Subject: RE: Revised plans - Cemetery St proj 102-375

Subject: Revised plans - Cemetery St

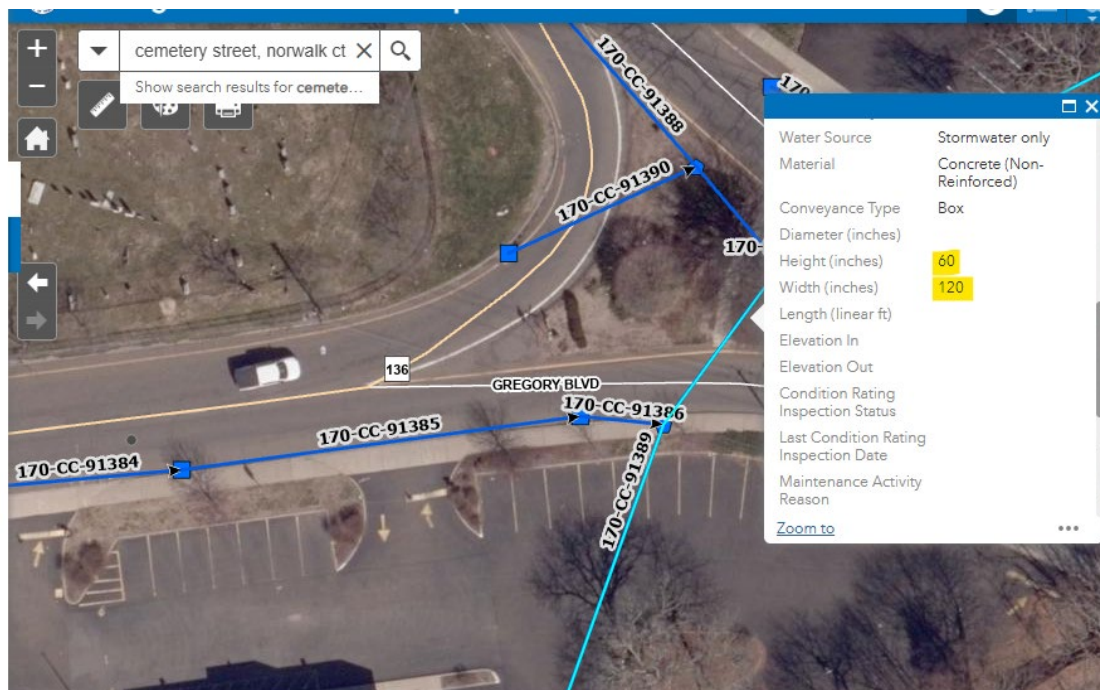
- The survey indicates that the existing RC box culvert is a 6' rise by 8' span. In CTDOT's Transportation Enterprise Data (TED) Portal, the structure is listed as a non-reinforced box culvert and is listed as 5' rise by 10' span:
